SITE SERVICING REPORT

Herongate HG-5

2851 Baycrest Drive

Prepared for Hazelview Investments
by IBI Group
December 23, 2021

Fire Flow Requirement from Fire Underwriters Survey

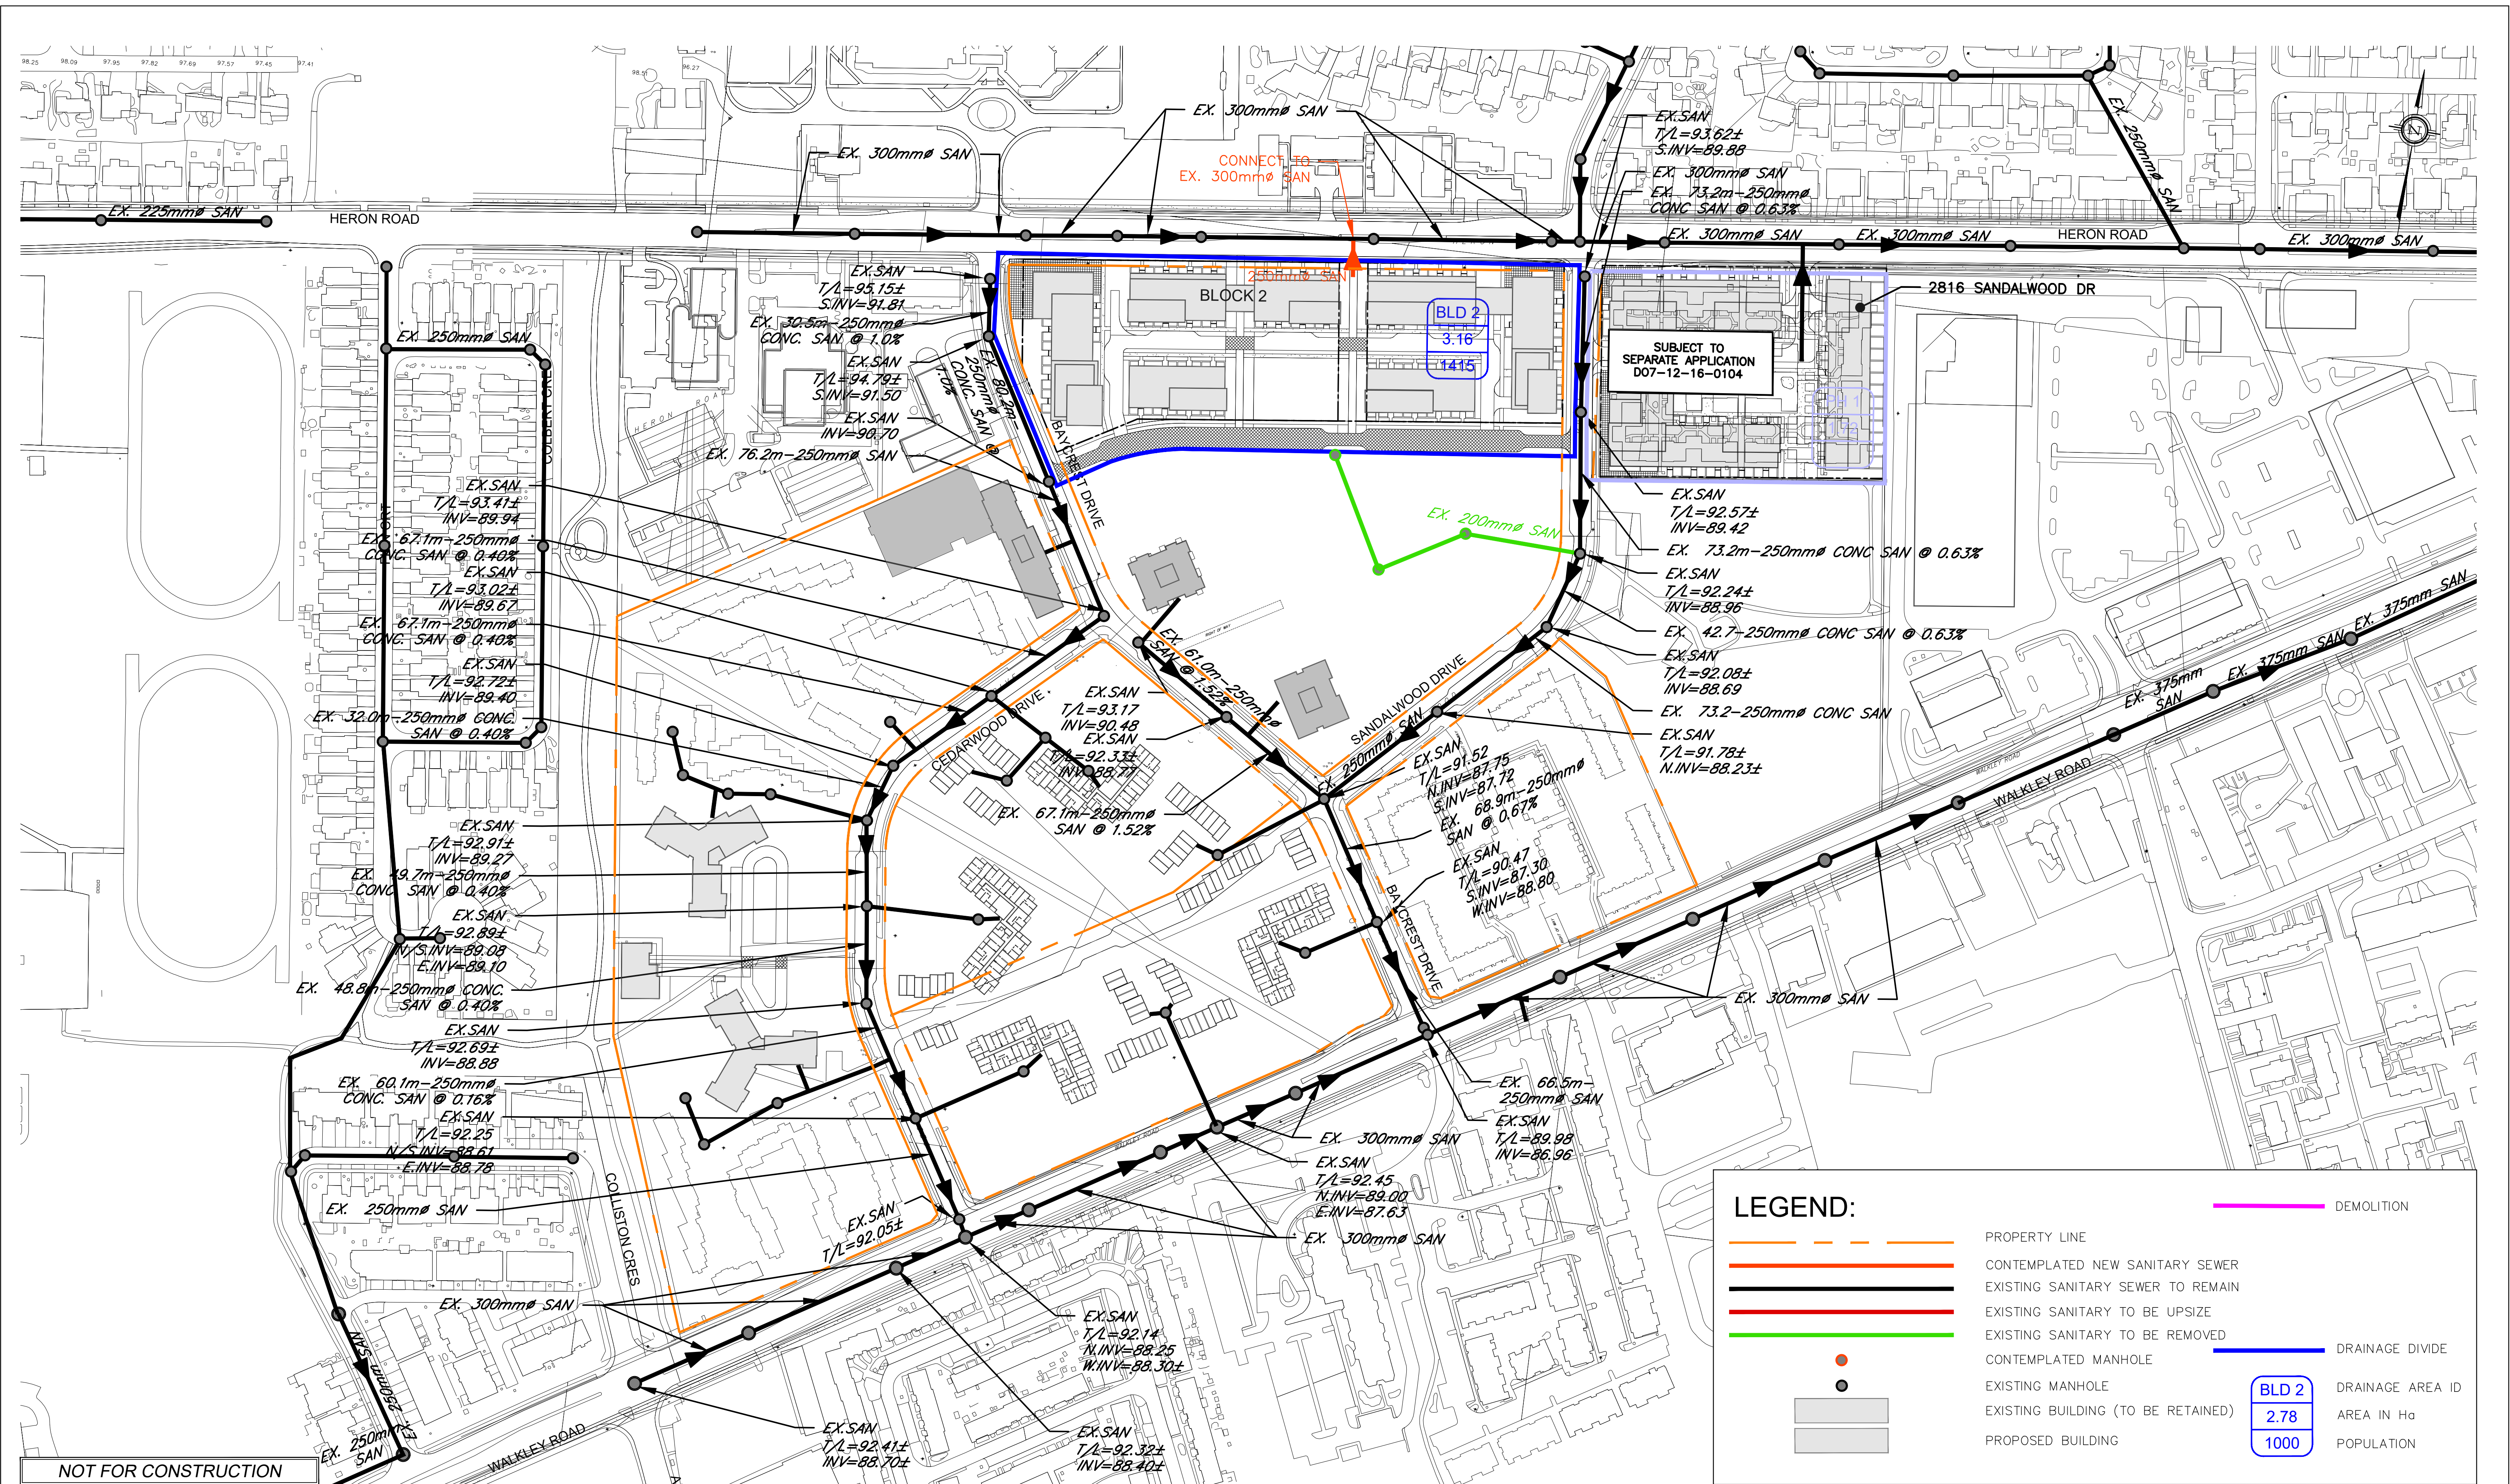
FUS calculations shall be completed for each tower separately and exposure factors shall be calculated accordingly. Please note, a standard water supply reduction of 10% should be considered and the floor area reduction is only applicable to fire resistive buildings with a construction coefficient of 0.6. Please provide revised FUS calculations.

Revised.

STORMWATER MANAGEMENT

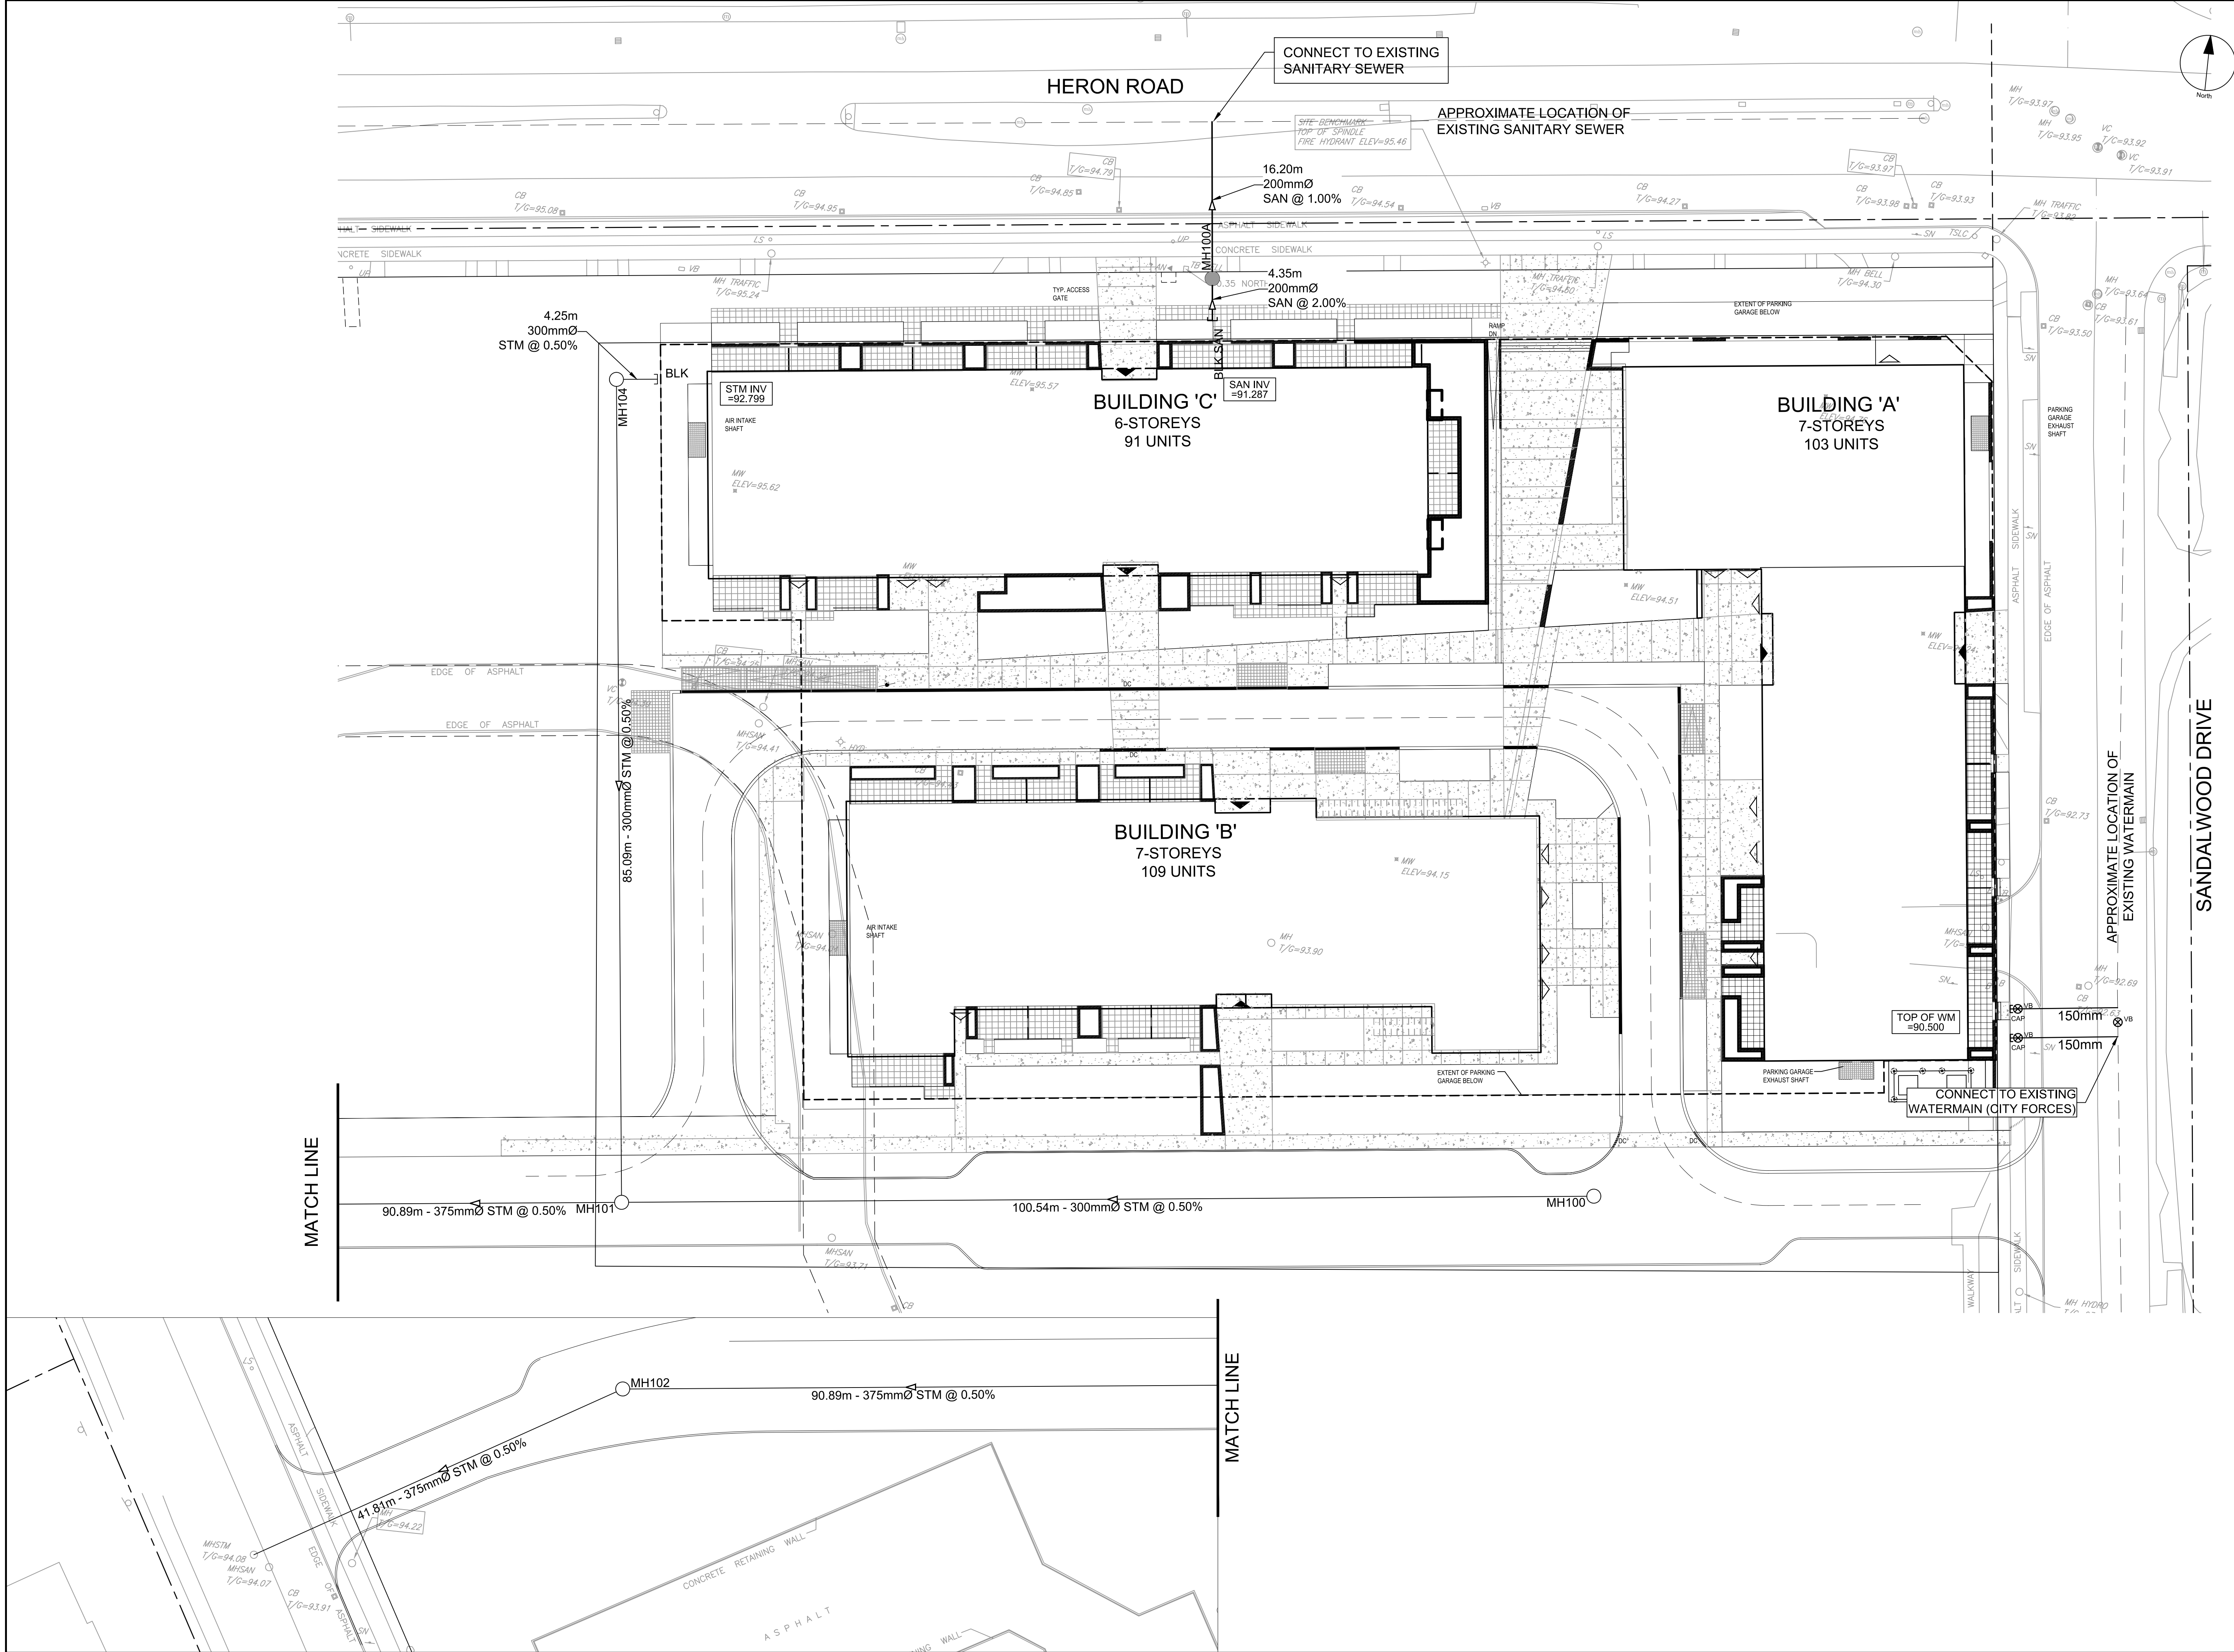
Does the pump flow at 45 L/s regardless of the water elevation in the cistern? Please clarify.

Please provide the technical details and calculations for the rooftop storage and surface ponding areas.

The technical details for the rooftop storage will be provided by the mechanical engineer as part of their design submission. The surface ponding areas are now included in this report.
